1963 Corvette: Service Bulletin: Interim Production Changes

Subject: Interim Production Changes
Model and Year: 1963 Corvette
Source: Chevrolet Technical Service Bulletin
Bulletin No: DR #569
Section: XV
Date: December 31, 1962

PARKING BRAKE LEVER ASSEMBLY REPLACEMENT

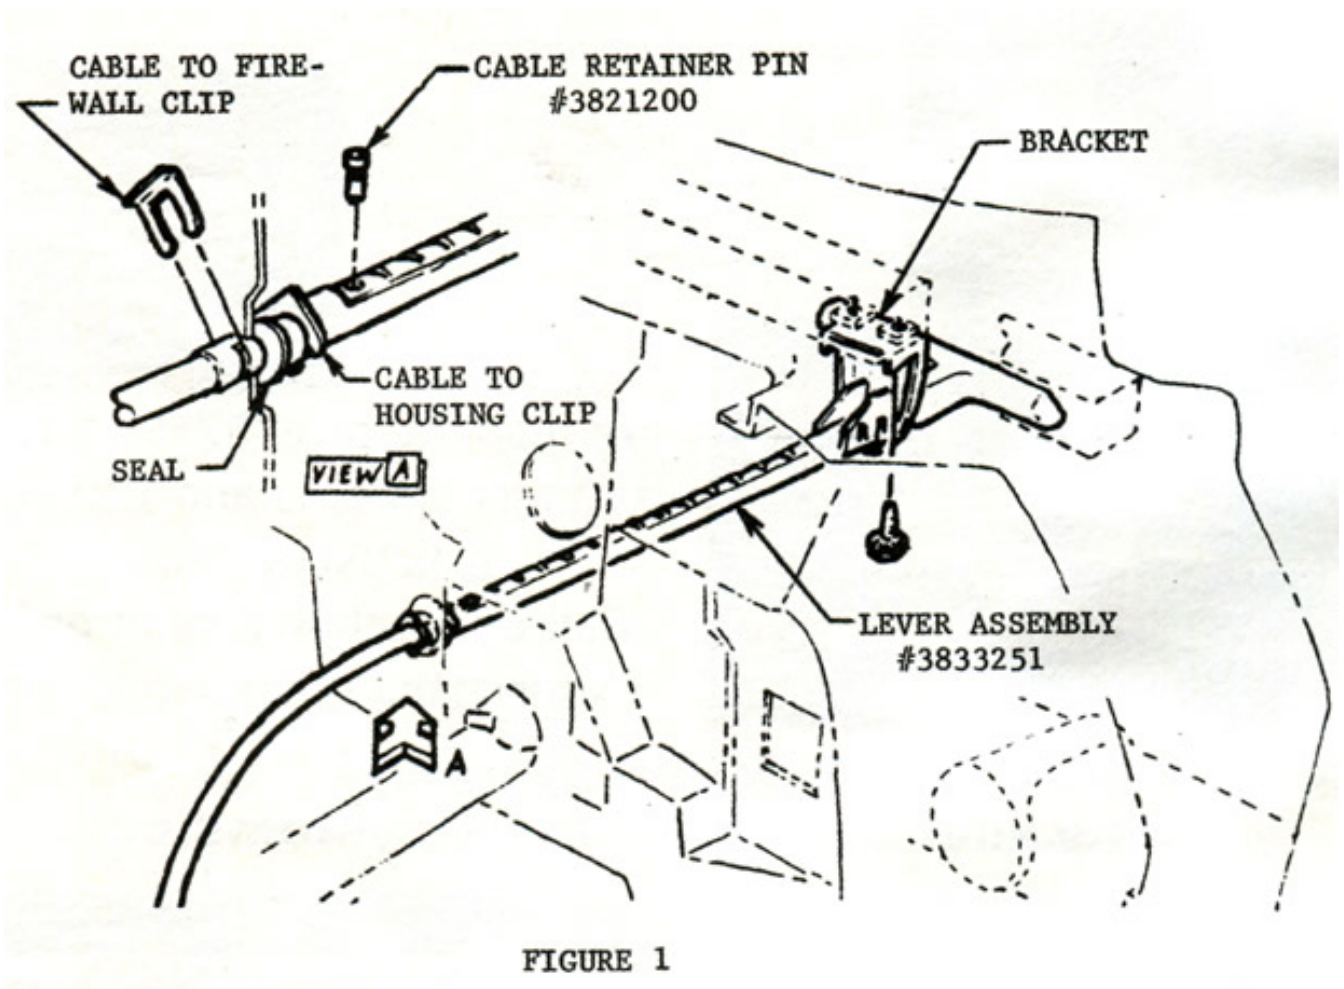
1. Effective with Serial No. S101893, a redesigned parking brake lever assembly entered Production. Early vehicles incorporate a lever assembly which may be difficult to release and in extreme cases, may actually jam making release impossible.
2. Vehicles with Serial No. S101847 through S102667, were built with a second design rear axle driveshaft flange that may not seat properly in the rear wheel drive spindle flange. An interference condition at this location could possibly lead to early failure of the rear wheel spindle flange attaching bolt bosses.

Lever Assembly should be replaced on all vehicles built prior to Serial No. S101893. Referring to Figure 1, proceed as follows:

1. Scrape sealer away from cable to firewall clip and remove clip.
2. Disconnect parking brake cable clip from steering gear retainer bolt.
3. Disconnect oil pressure line at gauge and pull line out of parking brake lever assembly bracket.
4. Remove two (2) bolts holding bracket to dash brace.
5. Pull complete lever and cable assembly to the rear, far enough to remove parking brake signal switch.
6. With handle all the way in, cable retainer pin will line up with hole in bottom of housing allowing pin to be driven out from bottom with a punch.
7. Remove cable to housing clip and separate cable from housing.
8. Install original seal on new lever assembly No. 3833251.
9. Reassemble by reversing the above steps using new cable retainer pin No. 3821200. NOTE: Chamfered side of pin must face forward to

actuate the parking brake signal switch properly.

10. Apply body sealer around cable at firewall to prevent water leaks.

FIGURE 2

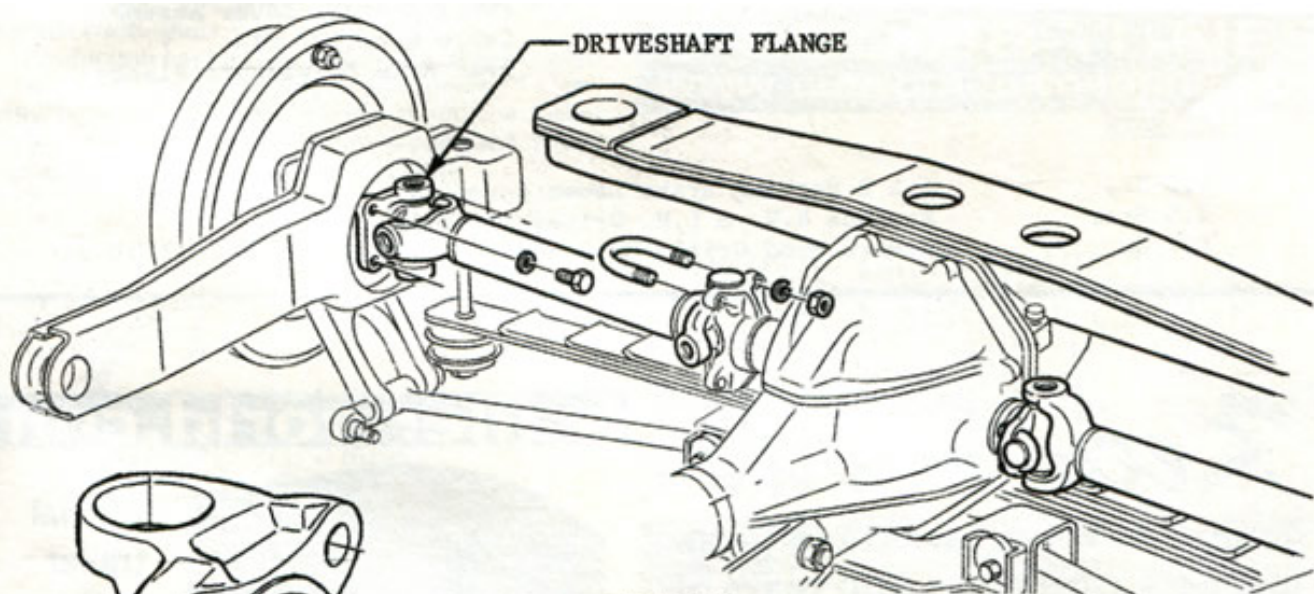
New machined Driveshaft Flanges No. 3832048, should be installed on all vehicles with Serial No. S101847 through S102667 (Ref. Figs. 2 and 3).

Vehicles built after S102667 incorporate selective fit pieces or additional machining to insure adequate clearance.

FIGURE 3 - DRIVESHAFT FLANGE

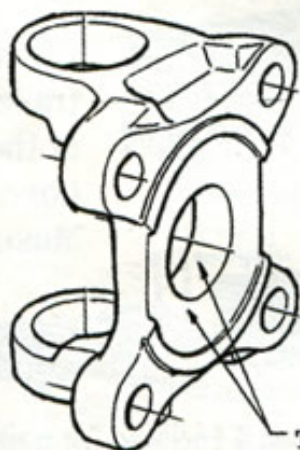
THESE SURFACES
MACHINED FOR
CLEARANCE

FIGURE 4 - SPINDLE FLANGE

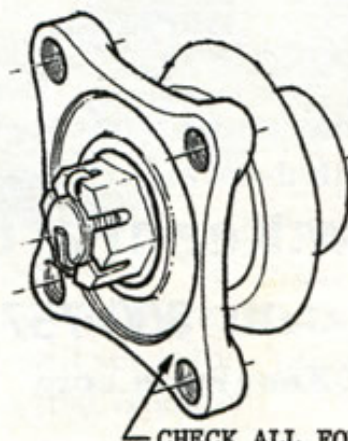
Replacement of the driveshaft flange is covered in the 1963 Corvette Shop Manual, Page 4-16. The rear wheel spindle flange attaching bolt bosses should be visually inspected while the axle driveshafts are out of the vehicle. Replace with new Spindle Flange Assembly No. 3830253 if any cracks are evident in the area indicated in Figure 4.

CHECK ALL FOUR
BOSSES FOR CRACKS
IN THIS AREA
